## UNITED STATES DEPARTMENT OF THE INTERIOR BUREAU OF LAND MANAGEMENT

**SUNDRY NOTICES AND REPORTS ON WELLS**

SUBMIT IN TRI	7. If Unit or CA/Agreement, Name and/or No. NMNM134086							
Type of Well	8. Well Name and No. CEDAR LAKE FEDERAL CA 640H							
2. Name of Operator APACHE CORPORATION	9. API Well No. 30-015-42900-00-S1							
3a. Address 303 VETERANS AIRPARK LA MIDLAND, TX 79705	ANE SUITE 3000	. (include area code 37-5400 Ext: 117 7-5401		10. Field and Pool, or Exploratory CEDAR LAKE-GLORIETA-YESO

PAD#12 NFE FEDERAL # 40+, #41+, #42+, #43+, #44+ # 45+

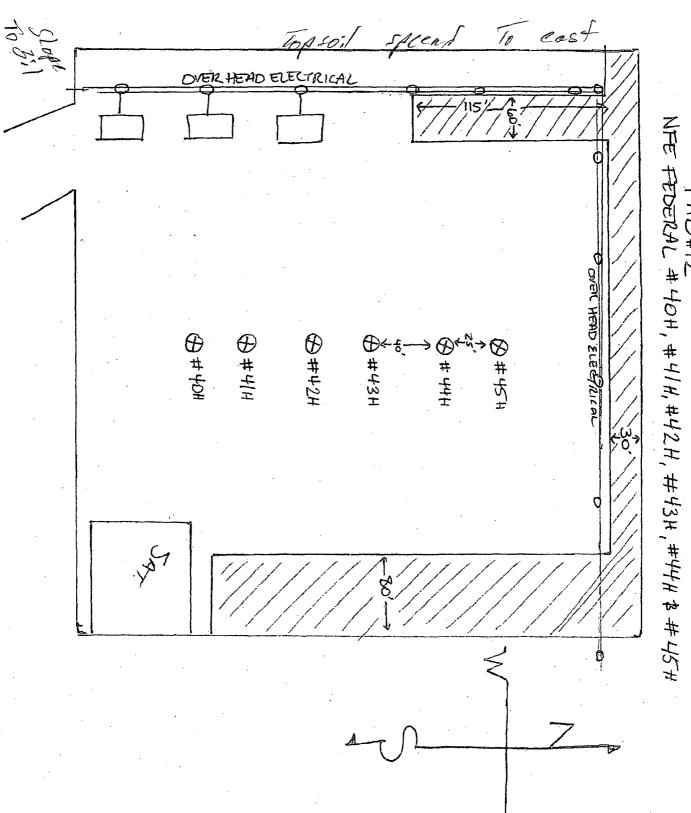
12. CHECK APPI	ROPRIATE BOX(ES) TO	O INDICATE	NATURE OF	NOTICE, R	EPORT, OR OTHER	RDATA		
TYPE OF SUBMISSION		F ACTION						
- National Classical	☐ Acidize	. □ Dee	pen	☐ Product	ion (Start/Resume)	☐ Water Shut-Off		
☑ Notice of Intent	☐ Alter Casing	☐ Frac	cture Treat	🛭 Reclam	ation	■ Well Integrity		
☐ Subsequent Report	□ Casing Repair	□ Nev	v Construction	☐ Recom	olete	Other		
☐ Final Abandonment Notice	Change Plans	Change Plans		☐ Temporarily Abandon				
	☐ Convert to Injection	🗖 Plug	g Back	☐ Water I	Disposal	. •		
testing has been completed. Final Abandonment Notices shall be filed only after all requirements, including reclamation, have been completed, and the operator has determined that the site is ready for final inspection.)  APACHE REQUESTS TO REVISE / CHANGE THE ORIGINAL PLANS FOR THE INTERIM RECLAMATION (IR) FOR THE FOLLOWING WELLS.  LEASE # NMLC029435B  NFE FEDERAL 40H - 30-015-42900  NFE FEDERAL 41H - 30-015-42901  NFE FEDERAL 42H - 30-015-42902  NFE FEDERAL 43H - 30-015-42903  NFE FEDERAL 44H - 30-015-42904  NFE FEDERAL 45H - 30-015-42906  ORIGINAL PLANS DID NOT ACCOUNT FOR THE SAFELLITE FACILITY LOCATED ON THE SOUTHEAST OR ELECTRICITY

WITH PANELS FOR EACH WELL TO THE NORTH OF THE ACCESS ROAD.

IR WORK TO BE COMPLETED? REMOVE ANY FRAC SAND AND UNUSED GRAVEL. CALICHE FREE OF ANY CONTAMINATION WILL BE REMOVED AND STOCKPILED FOR USE ON ROADS OR CONSTRUCTION OF WELL PADS. AREAS TO BE RECLAIMED WILL BE RECONTOURED TO MATCH SURROUNDING AREAS, THE TOPSOIL WILL BE DISTRIBUTED ACROSS ALL RECLAIMED AREAS, RIPPED ACROSS ANY SLOPED AREAS, AND SEEDED WITH BLM LPC SEED MIXTURE. WELL PAD WILL BE BERMED TO PREVENT CONTAMINANTS FROM LEAVING LOCATION IF AN UNDESIREABLE EVENT WAS TO OCCUR.

PLEASE SEE ATTACHED DIAGRAM OF REVISED PLAN.
